# Mobile Intel® Celeron® Processor on .13 Micron Process in Micro-FCPGA Package

Specification Update

Document Number: 251309-026

Figure 12. System Bus Reset and Configuration Timings

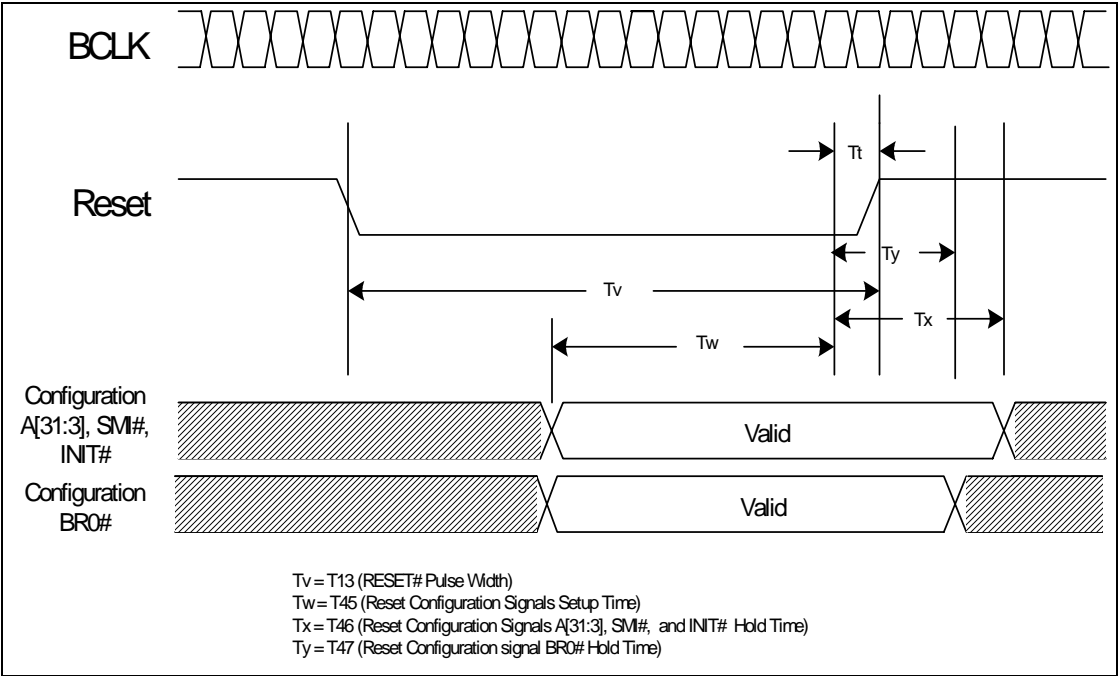
## V2. BR0# Maximum Hold Time Specification Change

The BR0# maximum hold time has changed to 2 BCLKs. This change will be shown in the “System Bus AC Specifications (Reset Conditions)” table and “System Bus Reset and Configuration Timings” figure of the *Mobile Intel® Celeron® Processor on .13 Micron Process in Micro-FCPGA Package Datasheet*. This change will be incorporated in the next revision of the datasheet.

The following figure will be modified to reflect this change:

T# Parameter	Min	Max	Unit	Figure	Notes
T45: Reset Configuration Signals (A[31:3]#, BR0# INIT#, SMI#) Setup Time	4		BCLKs	13	1
T46: Reset Configuration Signals (A[31:3]#, INIT#, SMI#) Hold Time	2	20	BCLKs	13	2
T47: Reset Configuration Signal BR0# Hold Time	2	2	BCLKs	13	2

1. Before the deassertion of RESET#.
2. After clock that deasserts RESET#.
